APPENDIX 1.3
SANG ENABLING WORKS FURTHER INFORMATION

RE: 20/S/00003 – further information and extension of time request in respect of proposed enabling works to facilitate the first phase of SANG at the former Wisley Airfield site, Wisley Airfield, Ockham Lane, Ockham

FORMER WISLEY AIRFIELD – BACKGROUND TO EIA SCREENING REQUEST FOR ENABLING WORKS FOR PART PHASE 1 OF SANG

Status	PRELIMINARY			
Client	Taylor Wimpey			
Architect	DAVIESLANDSCAPE ARCHITECTS			
Project	WISLEY AIRFIELD			
Title	NORTHERN SANG ENABLING AREA SURFACE WATER DRAINAGE STRATEGY			
Date	AUGUST 2020	Scale @ A1	1:2,500	
Clients Ref		Project Ref	10812	
Civils & Transport Gloucester House, 66a Church Walk, Burgess Hill, West Sussex, RH15 9AS Tel: 01444 871444 Web: www.gtacivils.co.uk				
Drawing Number	10812/1102	Rev.	P5

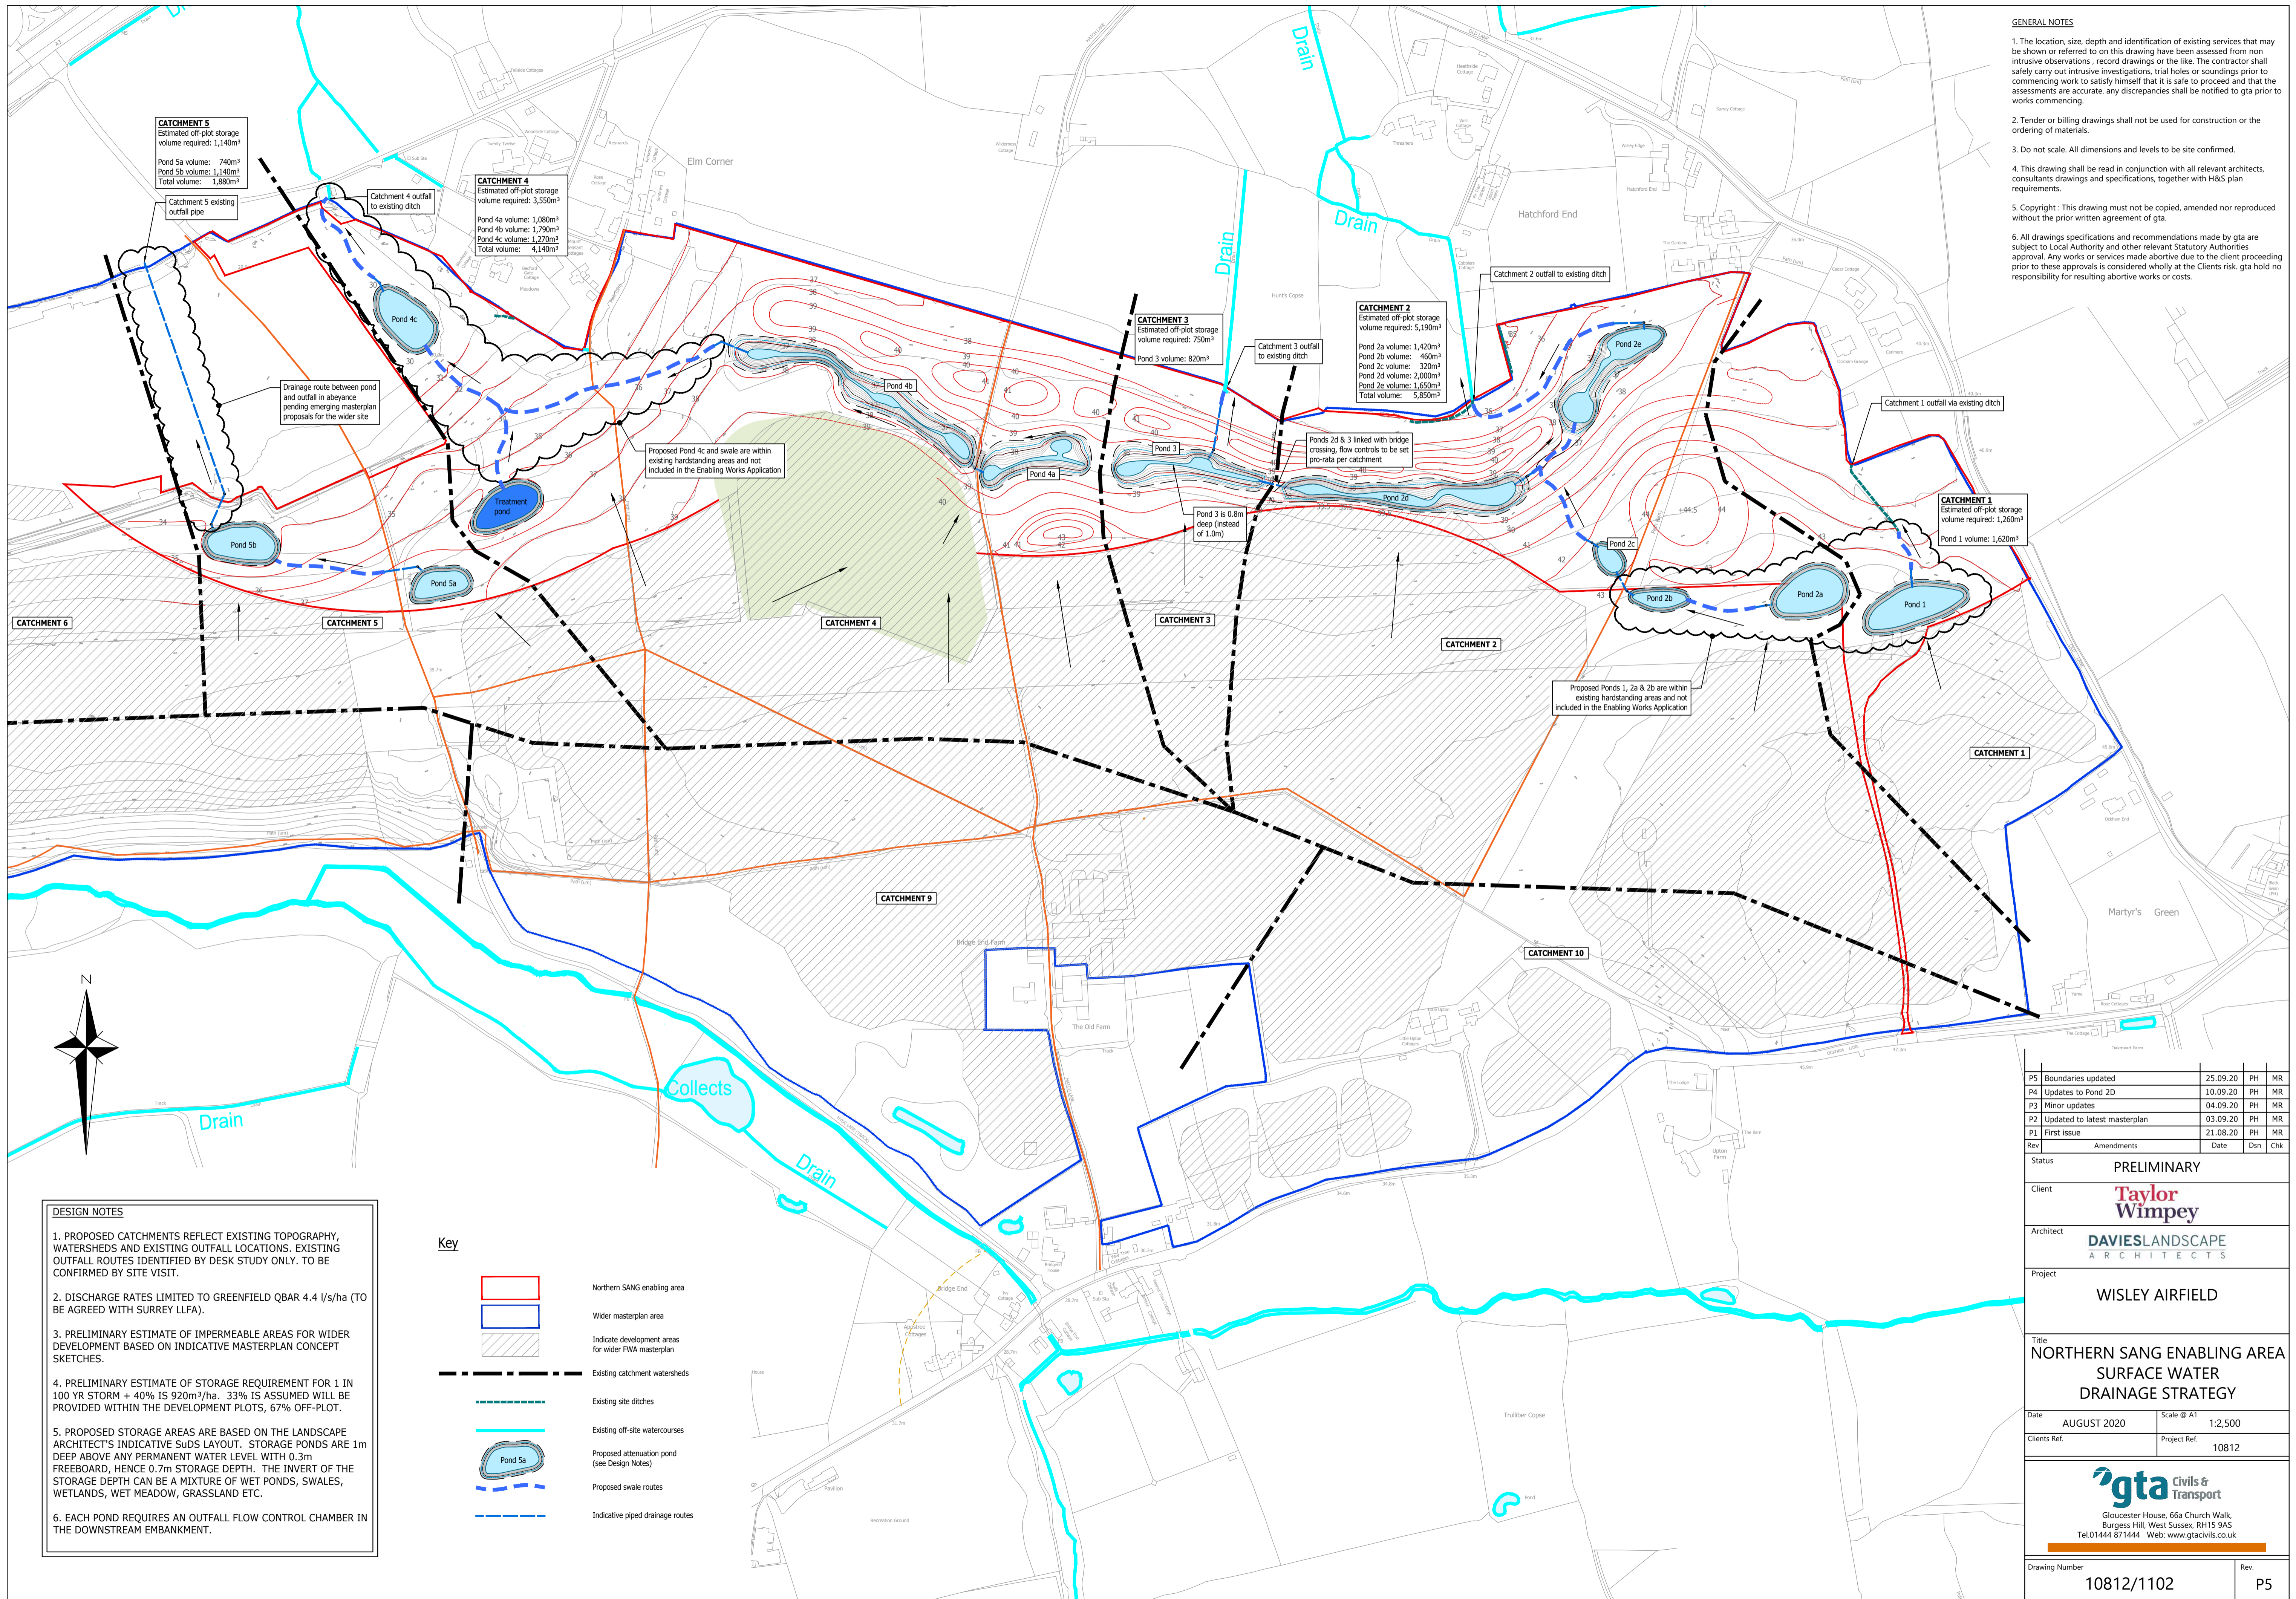
- 1. An updated plan of maximum earthworks changes (to Appendix 2 provided with the Screening Report) showing the indicative size, location and depth of the drainage basins together with justification of why they are needed. The current plan shows most of the changes as being +/- 2m. It is not clear which areas are intended for the drainage basins.**

2. Confirmation that the drainage strategy and basin capacity for the SANG is self-contained and does not include allowance for surface water drainage arising from the main housing development.

The surface water drainage plan submitted with the planning application is included at Appendix 2 of this letter. This shows the proposed size and location of drainage basins. The design notes in the bottom left-hand corner show that ponds would be 1m deep above any permanent water level with 0.3m freeboard, hence 0.7m storage depth. The basin size and storage capacity is based on calculation of the required attenuation volume for some of the proposed development zones, should a planning application for residential development at Wisley Airfield come forward in future (see also point 2 below).

Surface water from a future residential development at the former Wisley Airfield would drain to the attenuation basins in the SANG area. However, with reference to the case law precedent at Appendix 1, the enabling works, including creation of drainage basins, are capable of being delivered independently, without reliance on any potential future development. Without any such future development in place, the basins would exceed the capacity required for the SANG enabling works but with no likely significant effects on the environment arising.
